ADDENDUM NUMBER 01

RENOVATION OF SHERIDAN PARK PAVILION
4800 South Lake Drive
Cudahy, Wisconsin 53110

Date of Addendum: 6/16/2014

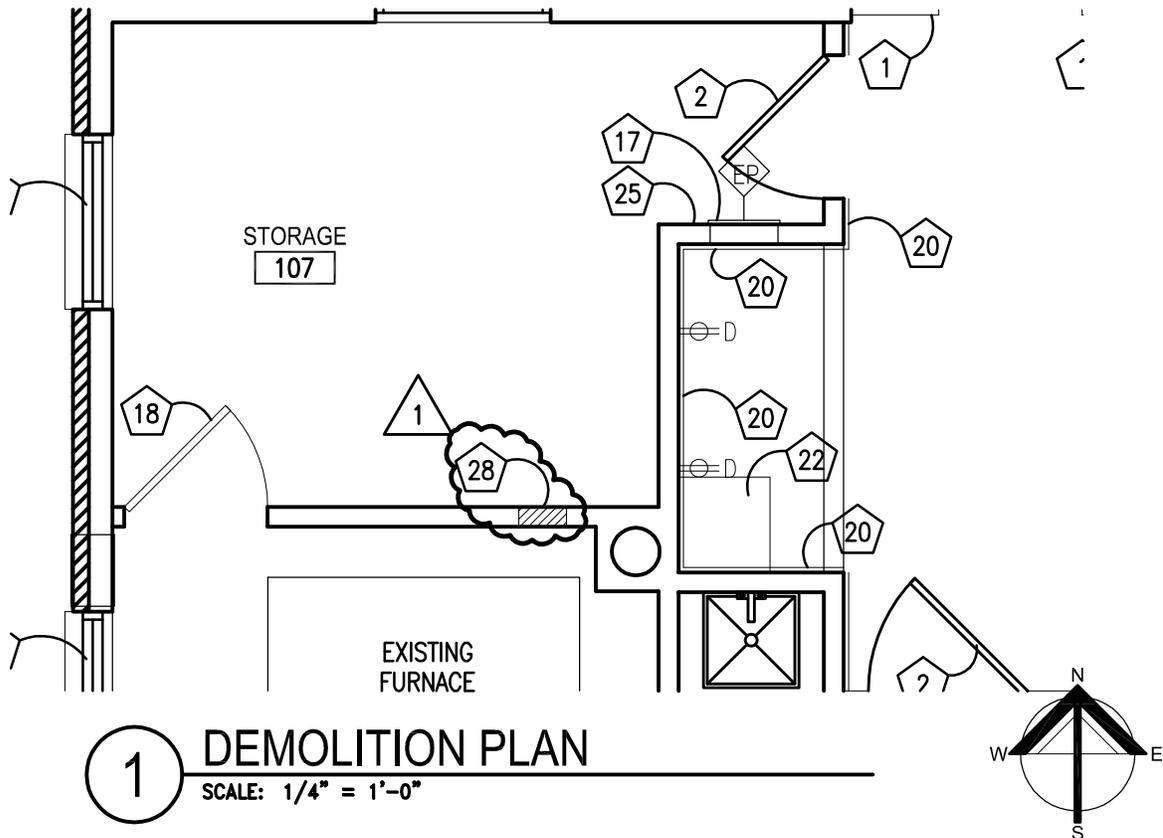
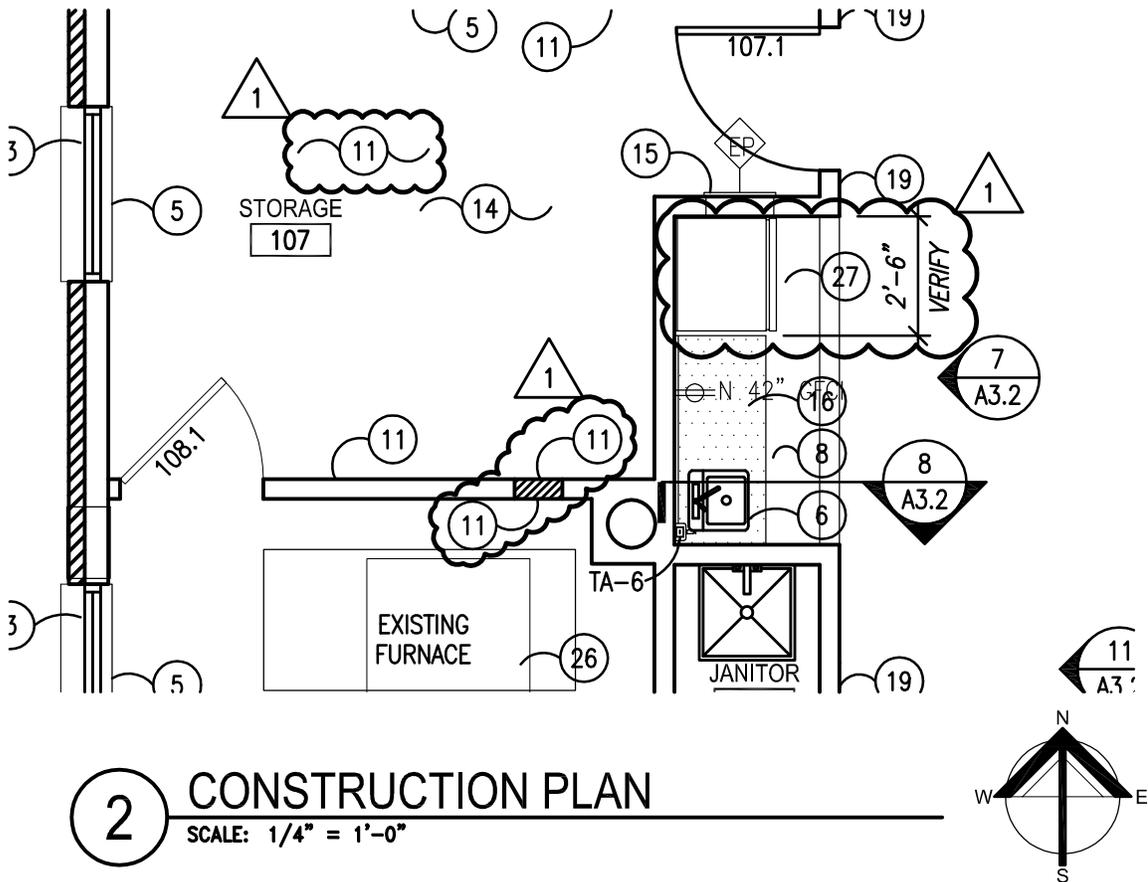
- 1. **Add** wall tags at the north wall of MENS 101 and WOMENS 102 to indicate Wall Type 5-SIM. See attached drawing A1.1-1.
- 2. **Add** note to indicate patching at the location of the removed louver between MECANICAL 108 and STORAGE 107 and general patching for STORAGE 107. See attached drawing A1.1-2.
- 3. **Revise** Demolition Note 9 to read: ABATEMENT CONTRACTOR TO REMOVE ALL WINDOWS SCHEDULE FOR REMOVAL UNDER SEPARATE CONTRACT. GENERAL CONTRACTOR TO COORDINATE SCHEDULING.
- 4. **Add** Demolition Note 28: REMOVE EXISTING LOUVER. See attached drawing A1.1-2.
- 5. **Add** Demolition Note 29: REMOVE ALL EXISTING GUTTERS AND DOWNSPOUTS. TURN OVER COPPER GUTTERS TO OWNER.
- 6. **Revise** refrigerator clearance size to be 2'-6". Coordinate with the Owner on the size of the refrigerator. See attached drawing A1.1-2.

REF. SHEET: A1.1
 DRAWING: A1.2-1

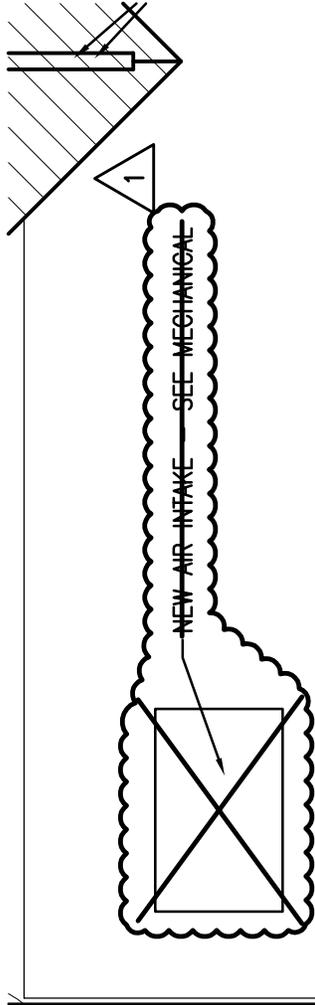
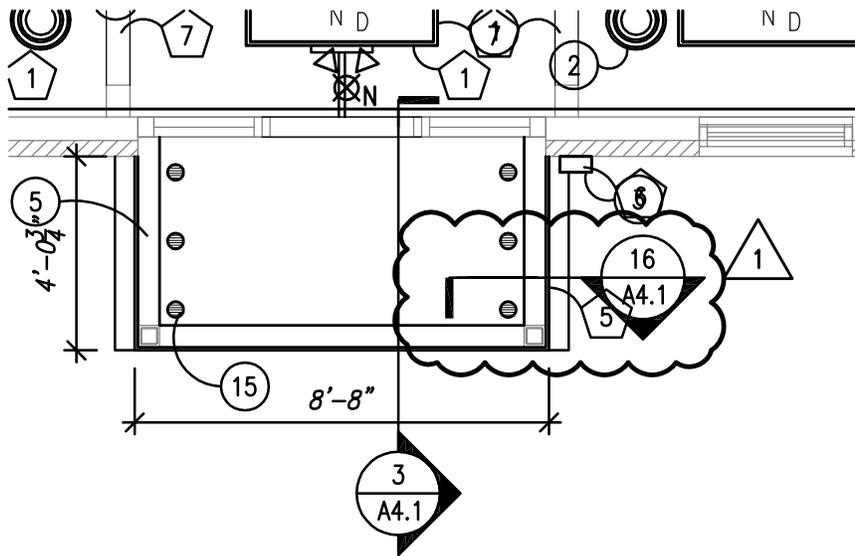
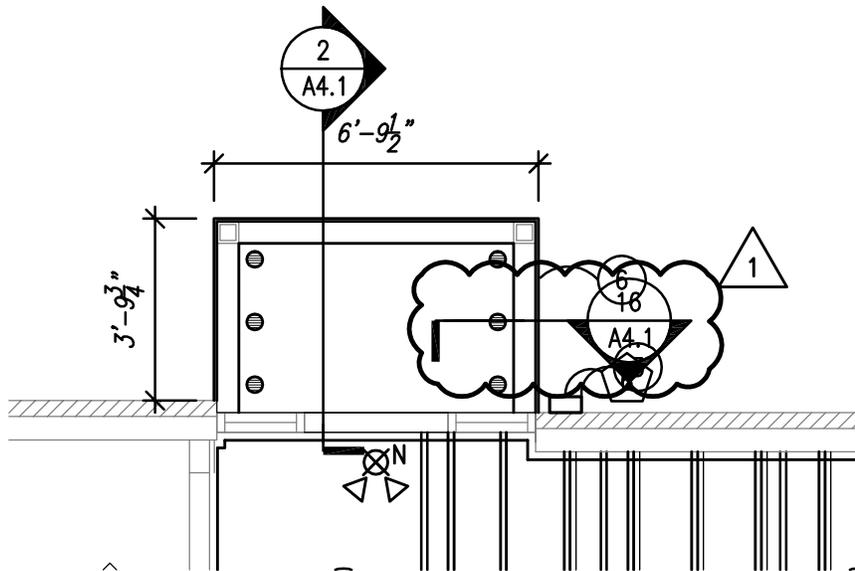
- 1. **Remove** new air intake note from roof. See attached drawing A1.2-1.
- 2. **Revise** note on Condenser Cage to read: PROVIDE PROPERTY ARMOR P3 BRAWLER FLIP OVER CONDENSER CAGE OR EQUAL. SECURE CAGE TO PAD PER MANUFACTURES SPECIFICATIONS. COORDINATE WITH METAL JACKETING TO PROTECT EXTERIOR REFRIGERANT LINES. SEE MECHANICAL DRAWINGS FOR SIZE OF CONDENSERS. See attached drawing A1.2-1.
- 3. **Add** a new ridge vent to each of the existing ridges as part of the re-roofing.

PROVIDE PROPERTY ARMOR P3 BRAWLER
 FLIP OVER CONDENSER CAGE OR EQUAL.
 SECURE CAGE TO PAD PER MANUFACTURES
 SPECIFICATIONS. COORDINATE WITH METAL
 JACKETING TO PROTECT EXTERIOR
 REFRIGERANT LINES. SEE MECHANICAL
 DRAWINGS FOR SIZE OF CONDENSERS

REF. SHEET:
A2.1
DRAWING:
A2.1-1

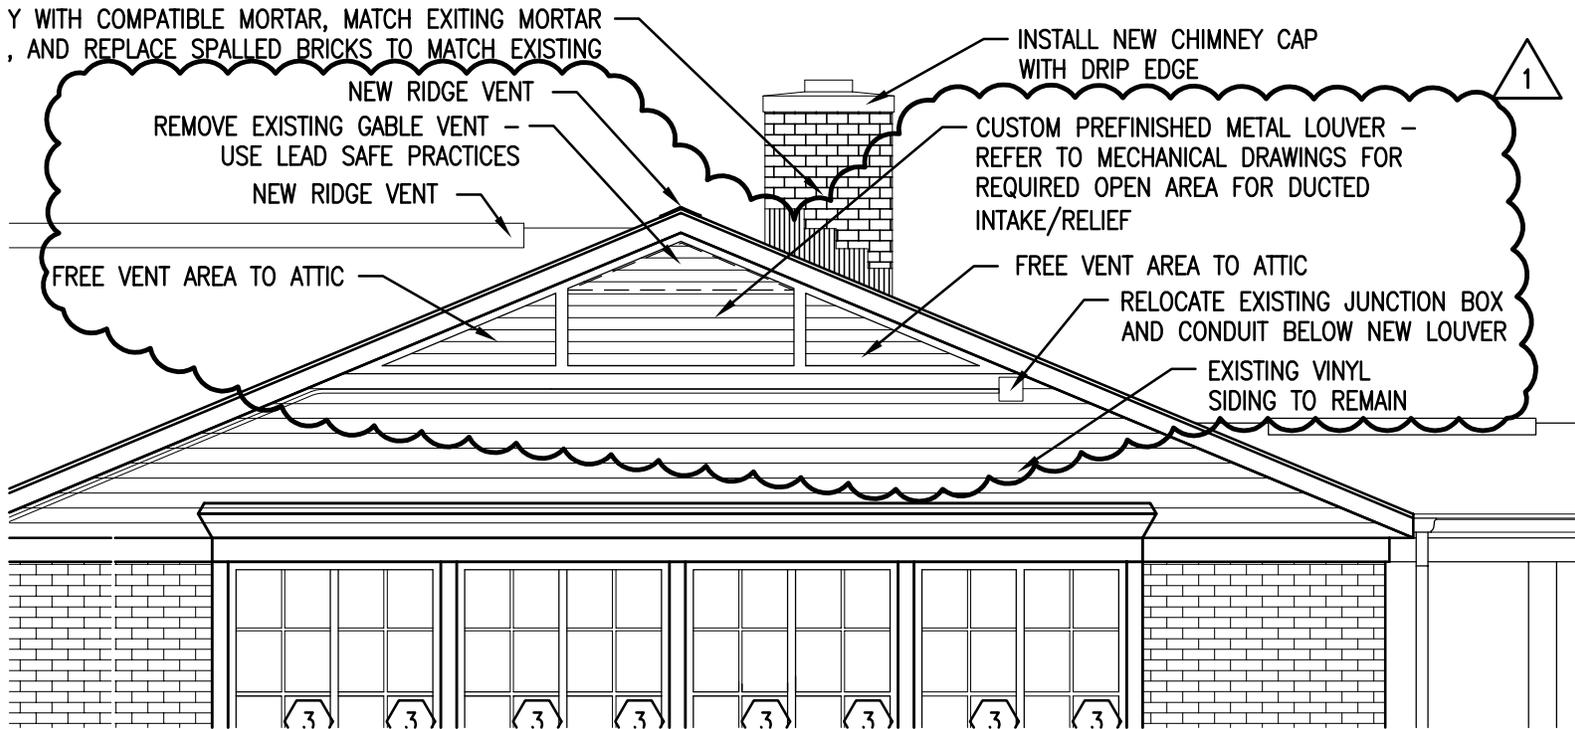
- 1. **Revise** detail tag to read 16/A4.1. See attached drawing A2.1-1.
- 2. **Add** detail tag at Alternate A overhang. See attached drawing A2.1-1.

REF. SHEET:
A3.1
DRAWING:
A3.1-1

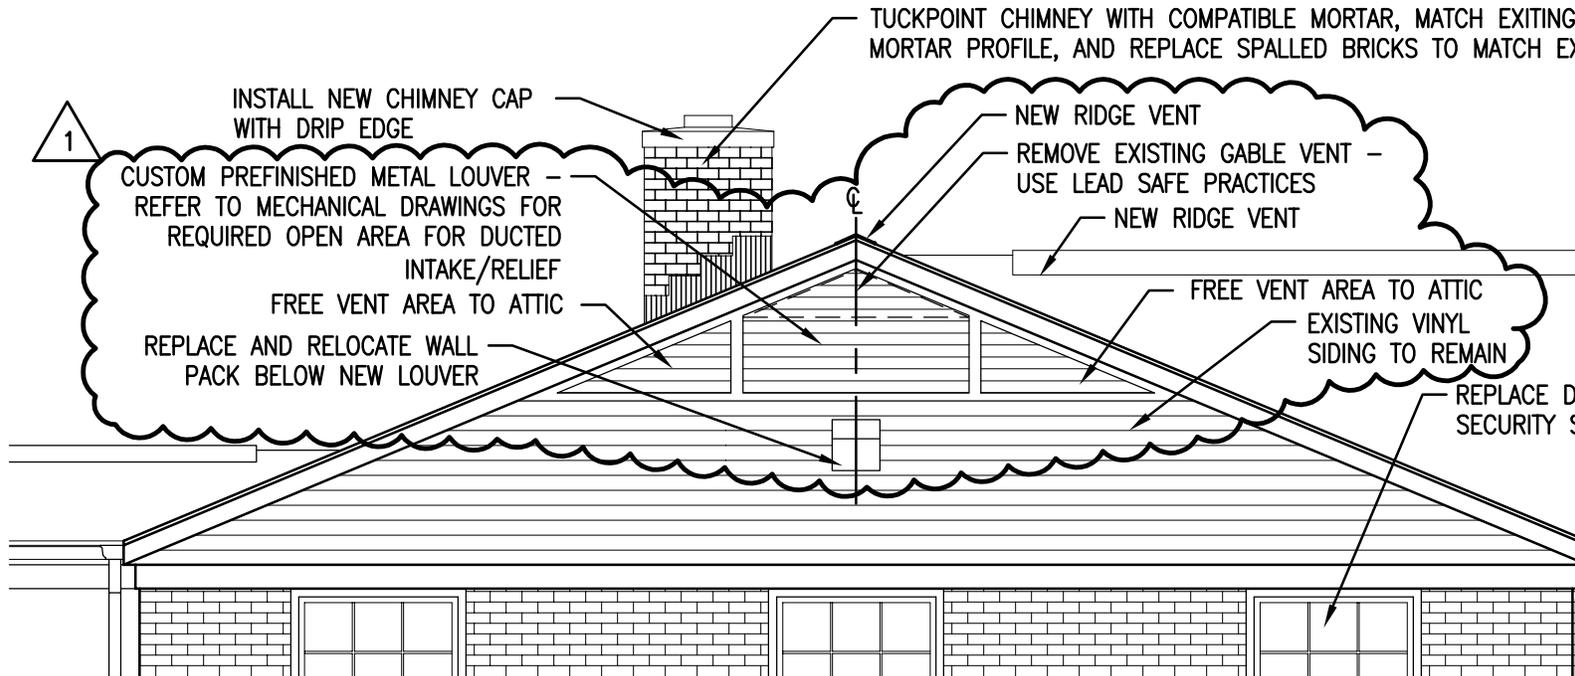
- 1. **Add** wall louvers at east and west gable ends. Coordinate louver size with Mechanical Drawings. See attached drawing A3.1-1.
- 2. **Add** typical note reference for Contractor to coordinate with Owner for the installation of rain barrels at downspout locations. See attached drawing A3.1-2.
- 3. **Add** typical note reference to include splash blocks at downspout locations. See attached

REF. SHEET: A3.1
DRAWING: A3.1-2
DATE: 06/16/2014
PROJECT: 8528-1SHPK
QUORUM - 14001.01
ADDENDUM: 01

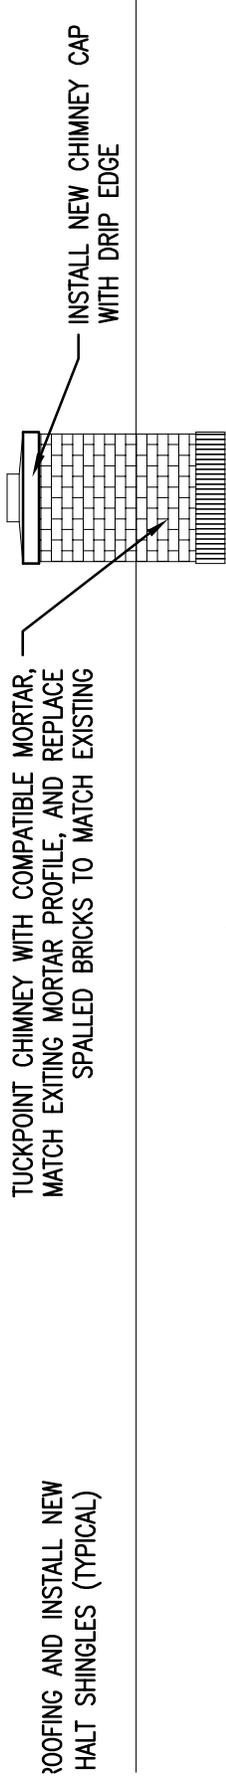
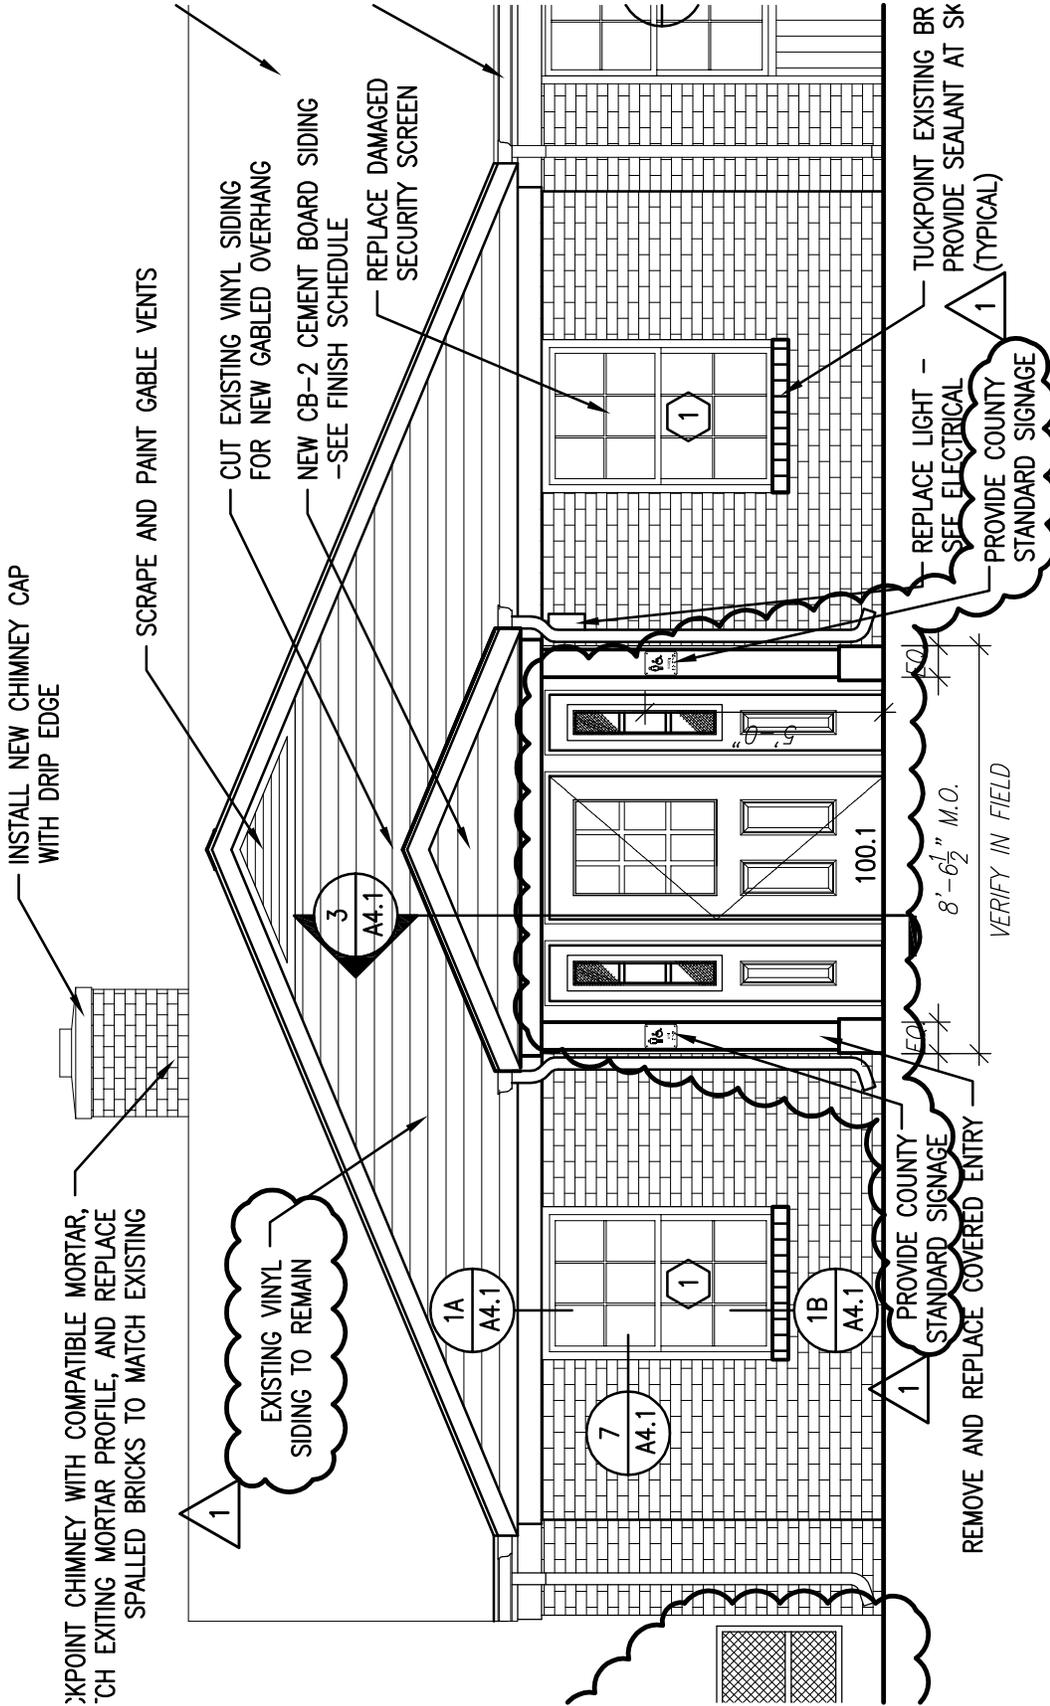
- drawing A3.1-2.
4. **Add** typical note to coordinate overhang downspout installation with light locations. See attached drawing A3.1-2.
 5. **Add** note at west, east, and south end gables "Existing vinyl siding to remain." See attached drawing A3.1-2.
 6. **Revise** North and South elevations to reflect new door details. See attached drawings A3.1-3 and A3.1-3.
 7. **Revise** west elevation to remove the brick infill at the north louver to accommodate a new mechanical louver in the same opening. See attached drawing A3.1-4.
 8. **Add** condenser and security cage to north and south elevations. See attached drawing A3.1-5.
